Report No. EGG-EA-5433

Adequacy of Station Electric Distribution System Voltages, Big Rock Point Plant,  
Docket No. 50-155, TAC No. 12781

Informal Report

May 1981

1. Big Rock Point electrical single-line diagram ..... 3

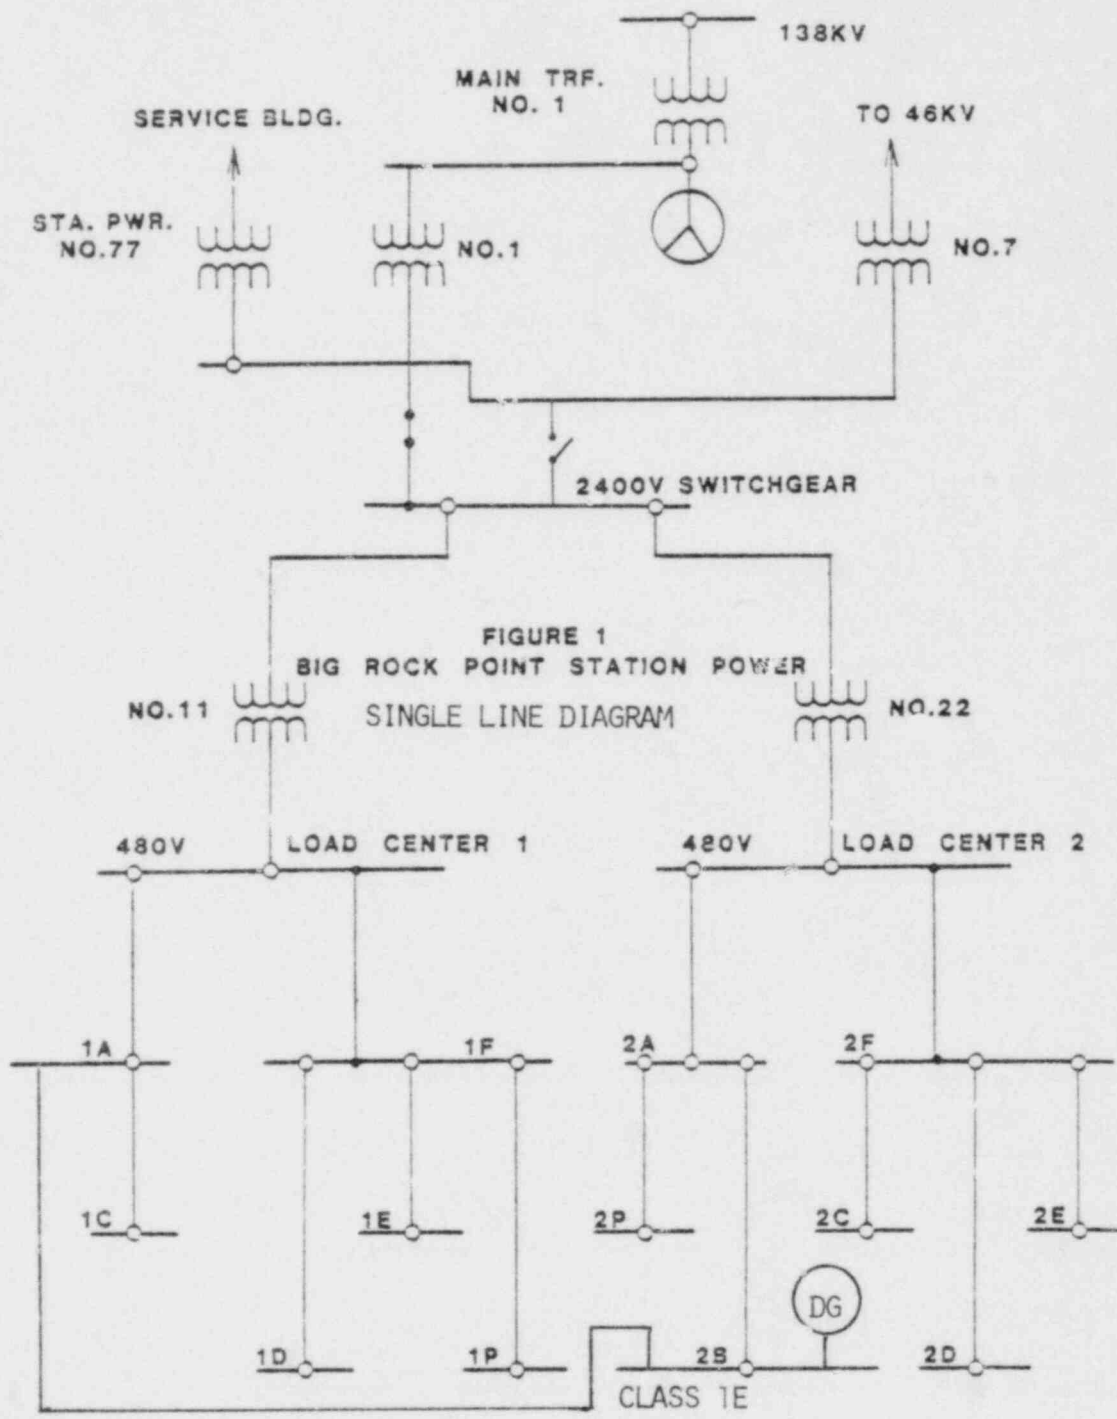
The Big Rock Point unit does not comply with GDC 17 since it has only one transformer connecting the offsite grid to the class 1E distribution system; it has only one circuit supplying 2400 V to the 2400/480V

transformers; and it has only one class 1E bus. This does not comply with GDC 17.

2. The test used to verify the analysis shows the analyses to be an accurate representation of the worst case conditions analyzed.
3. CPCo has determined that no potential for either a simultaneous or consequential loss of both offsite power sources exists. However, there are portions of the Big Rock Point distribution system where a single failure can negate both sources.
